Rezoning Application:

PD 25-0680

Development Services Department

AGENCY REVIEW COMMENT SHEET

8.0 PROPOSED SITE PLAN (FULL)

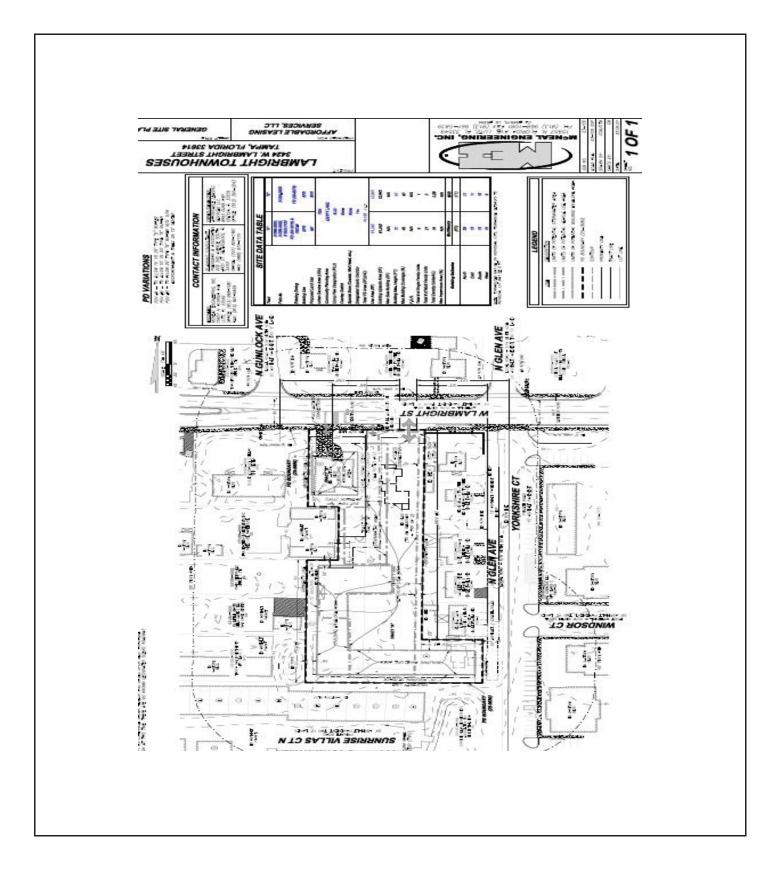
PRIOR TO CERTIFICATION, the applicant shall be required to amend the PD site plan to:

- Remove Replace note fourteen (14) under "Planning Notes" which requests a reduction in the required number of parking spaces with a statement that "parking will be provided in accordance with Hillsborough County Land Development Code Standards."
- Include a statement that "parking will be provided in accordance with Hillsborough County Land Development Code Standards."

SPACING EXHIBIT SCALE: 1" = 20'

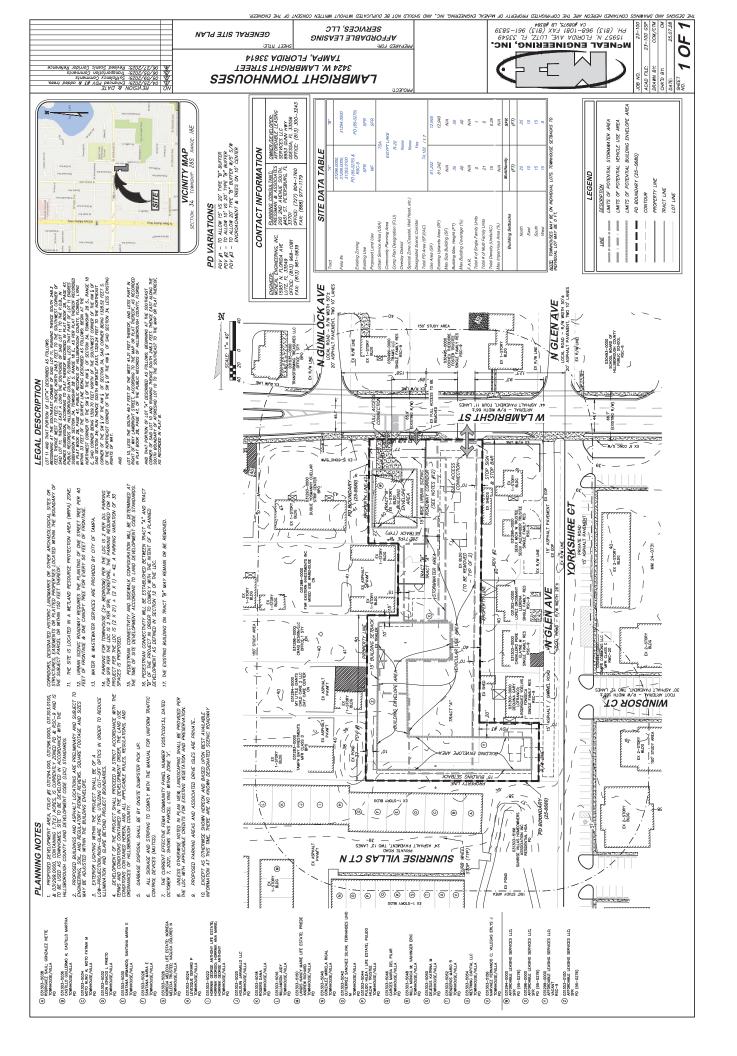
We are requesting a variance to increase the number of allowed access points from one to two on a Class 6 roadway. The existing and proposed driveway locations would serve the existing single-family residence while allowing a second to serve the townhomes.

- (b) The proposed location for the project access points do not appear that it would produce conflicts with direct access to Lambright Street. There has been only one crash per year for the last four years within 1,000 feet of this proposed access location. In addition, the project trip generation should have minimal impacts to the existing roadway network.
- (c) The proposed access locations would provide reasonable access for the proposed Zoning Modification. Without individual access, the existing single-family residence would require detrimental modification and is not feasible.
